Amendments to the Drawings:

REMARKS

This responds to the Office Action mailed on September 14, 2005. Claims 1-12 are currently pending. Applicants appreciate the indication that claims 7-10 contain allowable subject matter if rewritten in independent form. Claims 1-6 and 11-12 have been rejected.

FIG. 2

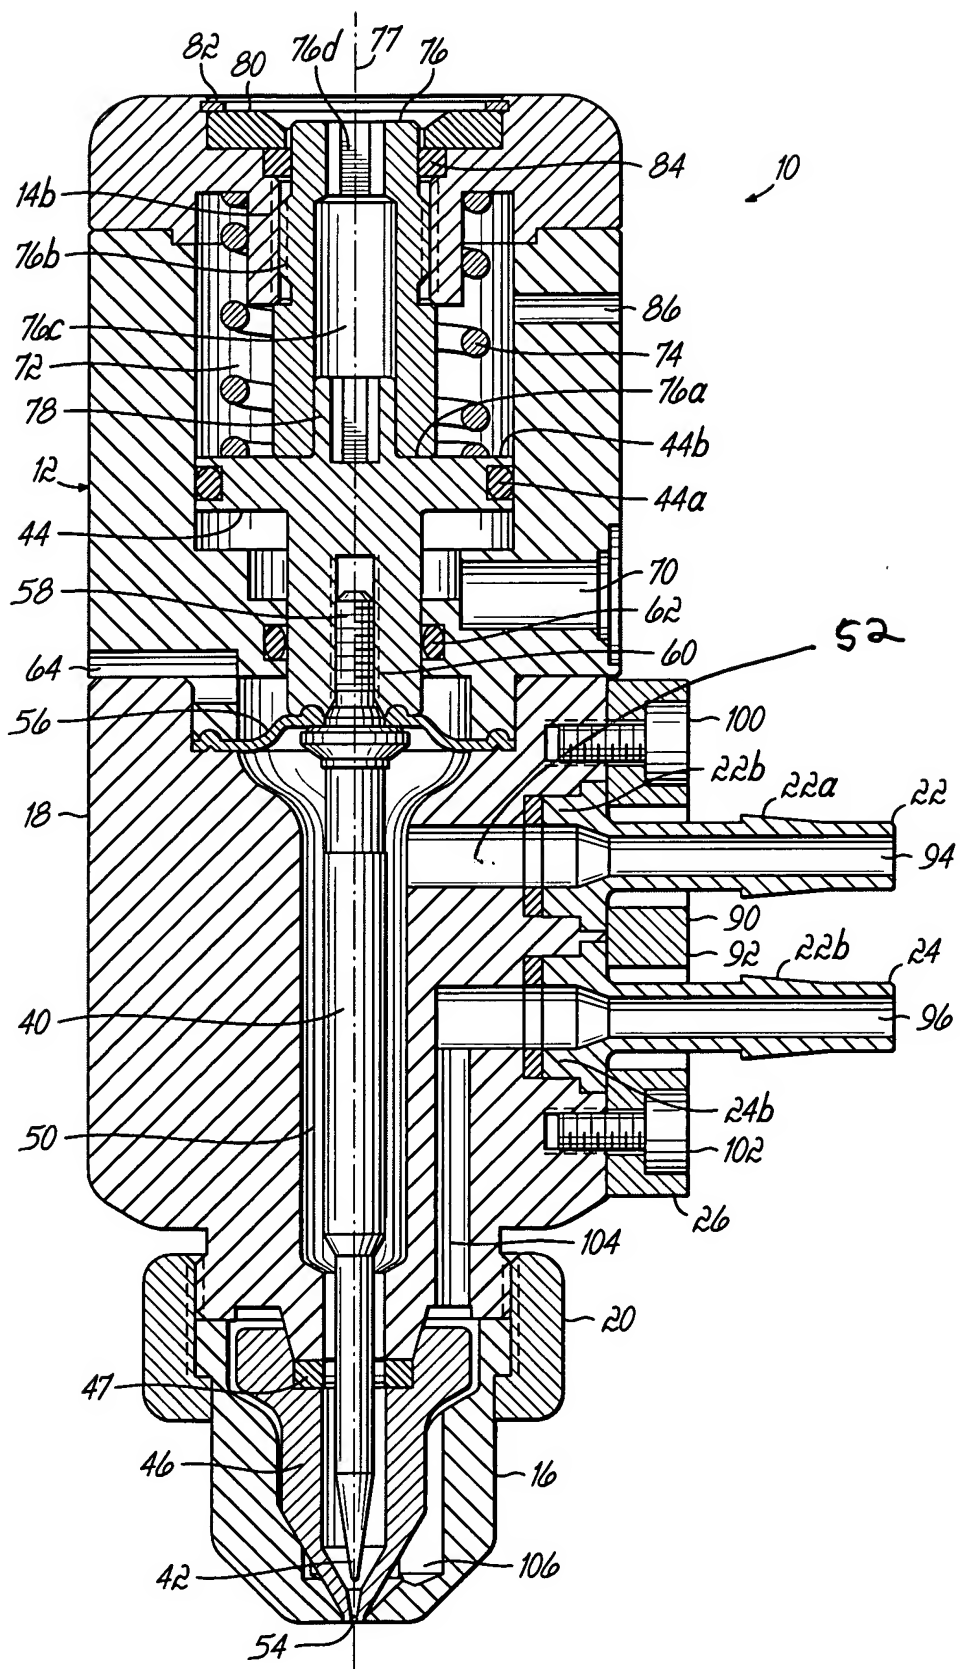
The drawings were objected to as failing to comply with 37 C.F.R. § 1.84(p)(5) because they do not include the numeral 52 discussed in paragraph 15, line 8, of the application. Applicants have provided corrected drawing sheets in compliance with 37 C.F.R. § 1.121(d) including the numeral 52. Applicants respectfully submit that the drawings are now in compliance with the applicable rules.

The attached sheets of drawings includes changes to Figs. 2 and 3.
